## DECISION OF THE PLANNING ADMINISTRATOR

**URBAN GROWTH PRELIMINARY DECLARATION / CLASS 3 SITE PLAN  
REVIEW / CLASS 2 ADJUSTMENT / CLASS 1 ADJUSTMENT / CLASS 2  
DRIVEWAY APPROACH PERMIT / CLASS 1 DESIGN REVIEW / PROPERTY  
LINE ADJUSTMENT CASE NO.: UGA-SPR-ADJ-DAP-DR-PLA24-03**

**APPLICATION NO.: 23-121805-PLN**

**NOTICE OF DECISION DATE:** February 29, 2024

## P5.1

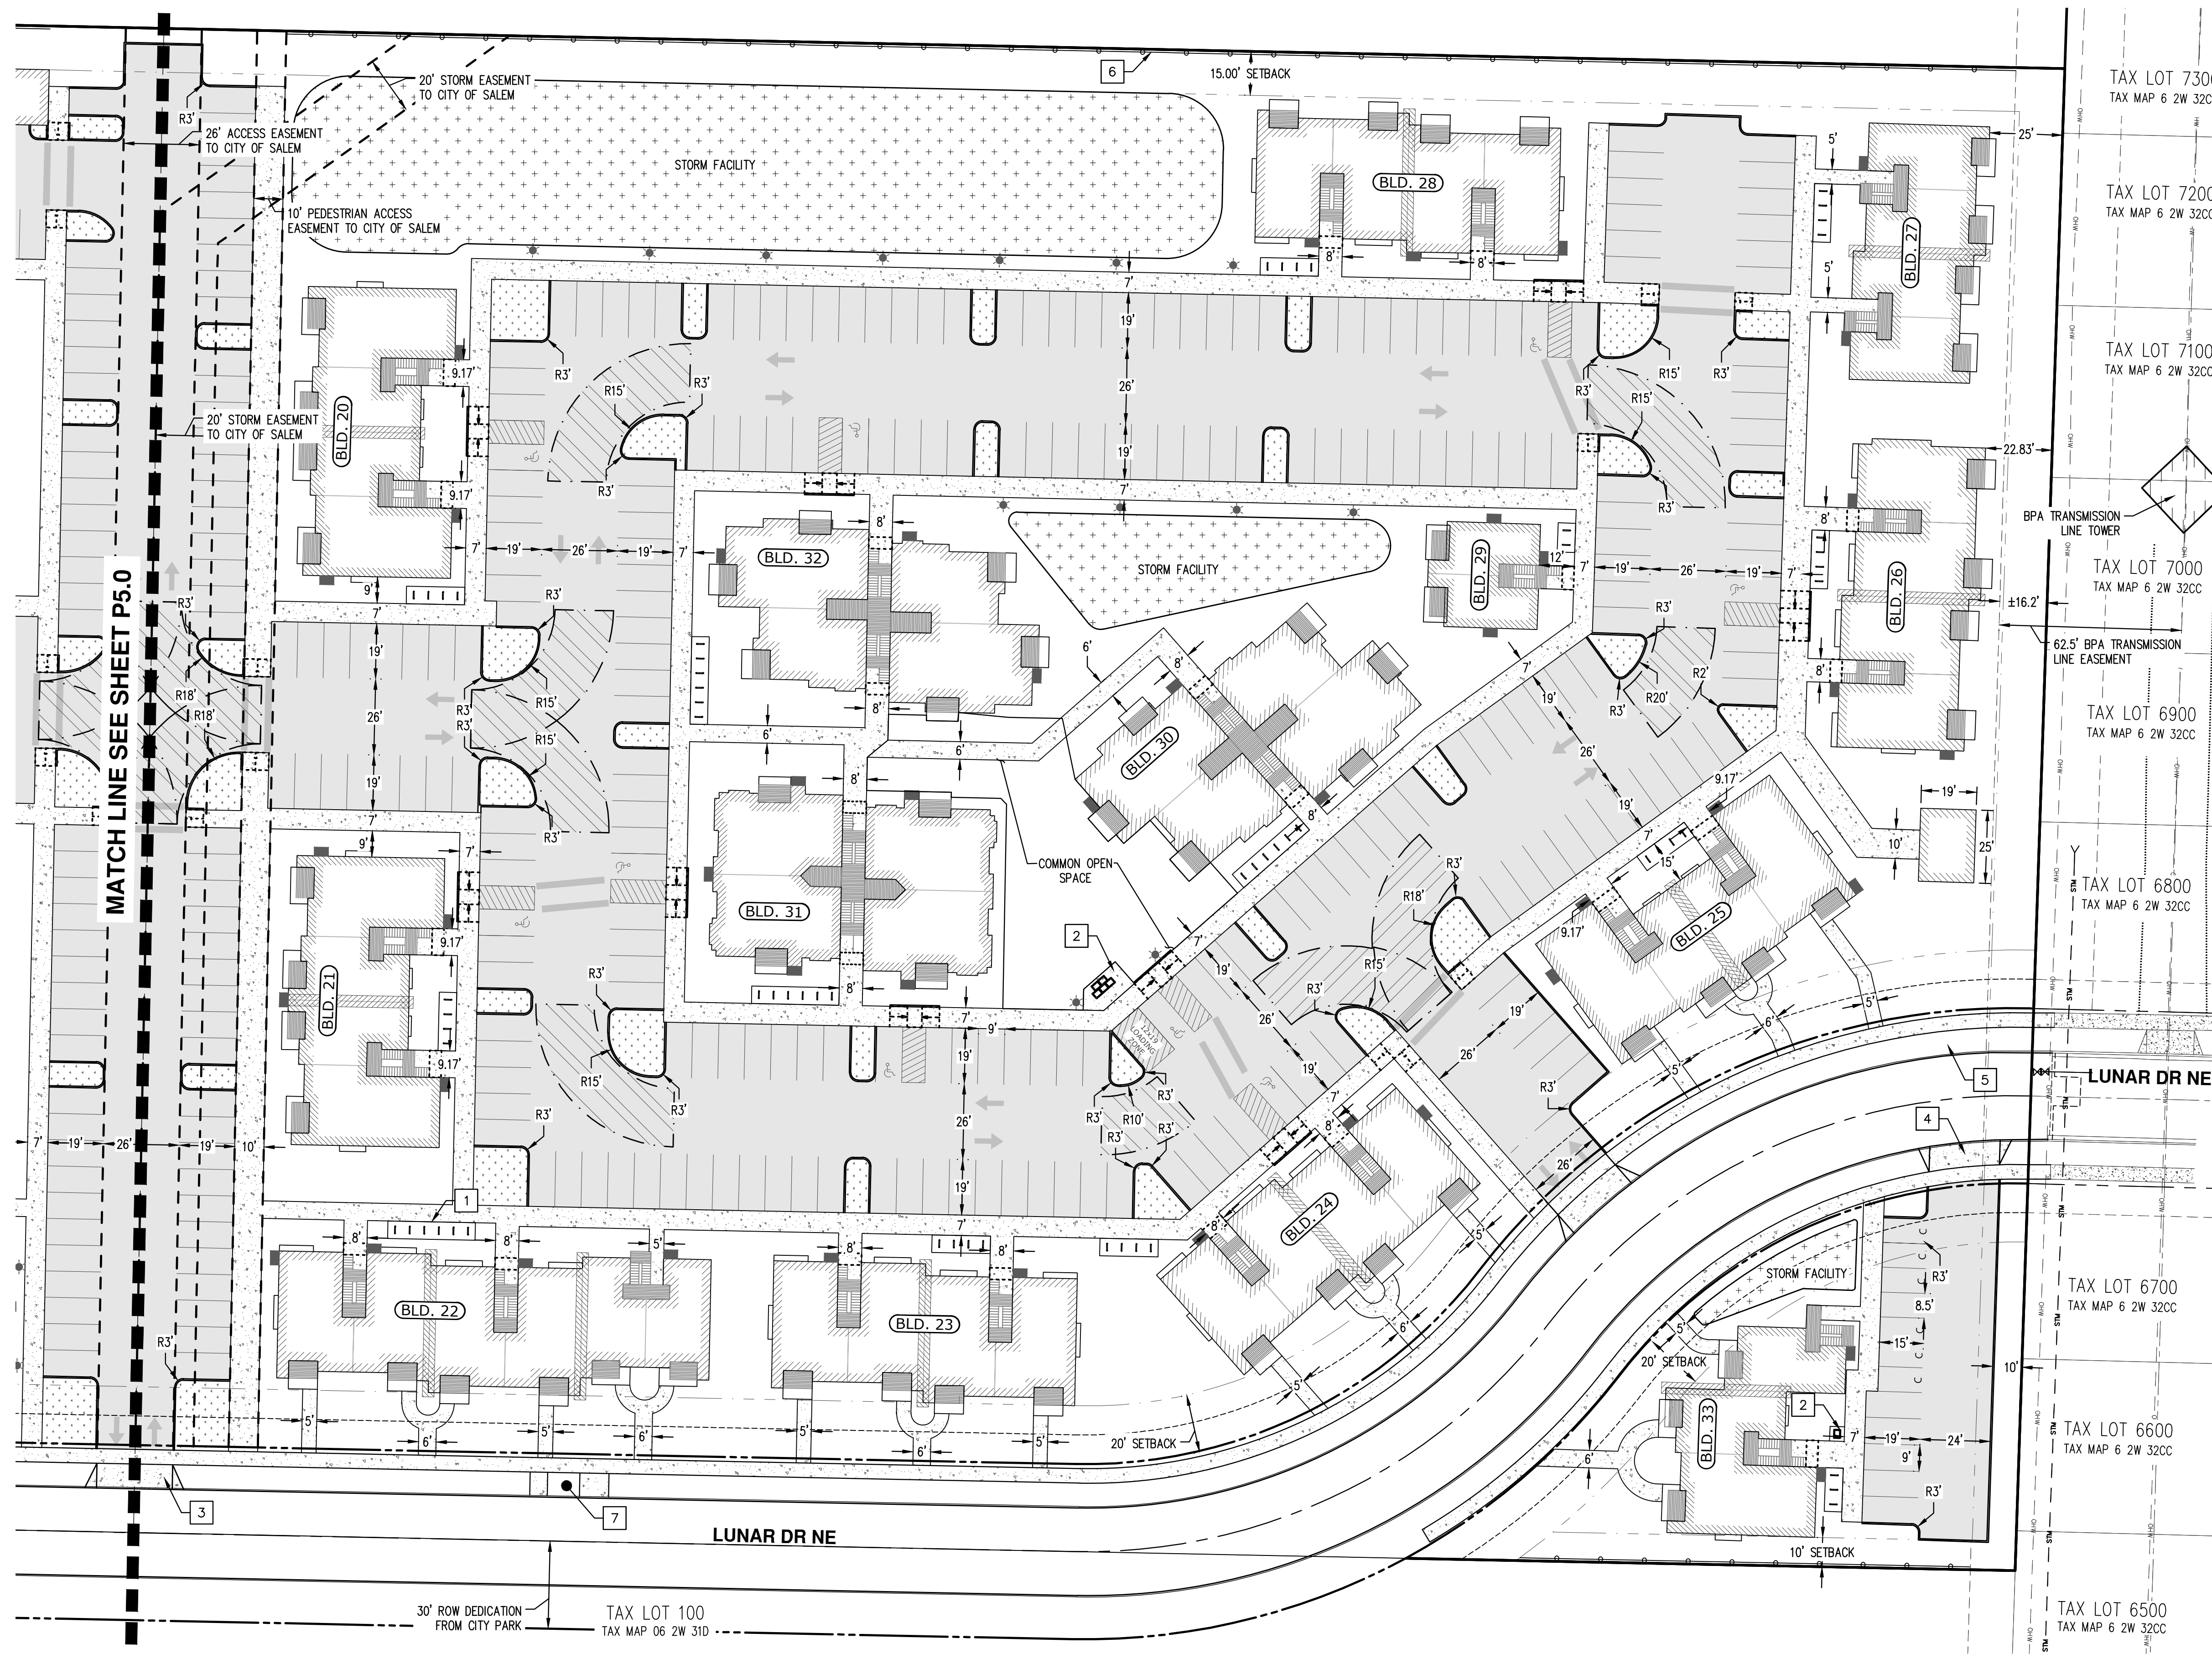
- 1) Hydrant and FDC shall not obstruct Fire Department access with hose lay. See sheet P7.0 near buildings 5 and 6.
- 2) Buildings that exceed 30 feet in height per the Oregon Fire Code require aerial access, 30-foot minimum. Appendix D105.3 as amended in SRC Chapter 58.

One of the transit stops shall be located on the east side of Lunar Drive at Building 5, approximately 50 feet north of the driveway as depicted in preliminary site plan drawing P5.0. The other transit stop shall be located at Building 22 as depicted in drawing P5.1 Note 7.
